TOSHIBA AMERICA CONSUMER PRODUCTS, INC.

# TECHNICAL BULLETIN

No.VCR9604

**Subject:** Part enhancement.

FIG. 1

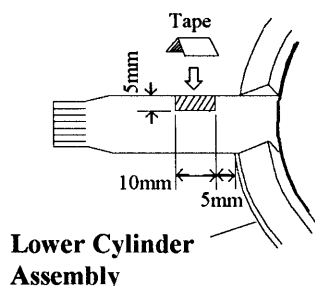
**Symptom:** No picture due to possible wear on FPC wire etching.

**Corrective Action:** Place cotton, vinyl, or acetate tape on the FPC (Flexible Printed Circuit) wire of the rotary transformer, as shown in fig. 1, to prevent shorting between the FPC and cylinder holding plate.

FIG. 2

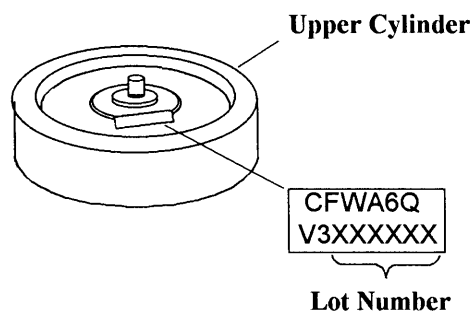
**Note:** This countermeasure should only be used if you encounter the above mentioned symptom and is applicable to the following lot numbers only: 941209 - 950113. The lot number is marked on the top of the cylinder head. (see fig. 2)
